Aqueous Solutions (owner) AQS-MFG-HDR_H2-GA_SIDE
HDR_H2 fabrication drawing GA_SIDE (AQS-PLAN-006 M3; graph R
Type: fabrication drawing (GA / nozzle orientation / part sheet) Rev 9e86944d Issued
Created: flow graph pipeline Approved: not approved (study)
Sheet 1 of 1 AQS-DWG-001

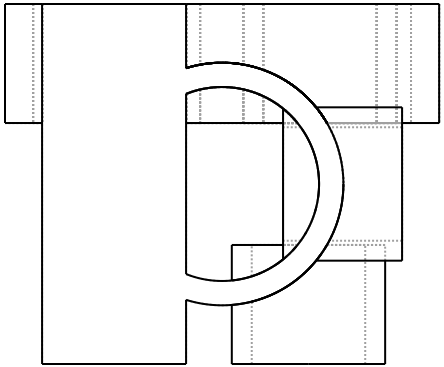
Graph revision AD - ga_side: Cross-section: the manifold sits at the centre of the 50 mm box and sits bonded in the trough plinth to its centreline
Graph revision AD - ga_side: AQS-DUTY-075 sizing: required bore 6.6 mm at 8 m/s, seat minimum DN25; the Sch 40 bore 26.94 mm seats the same DN; nothi
Graph revision AD - ga_side: The DN50 branch circles (OD 60.3) leave the 50 mm cross-section: the misfit is the ac
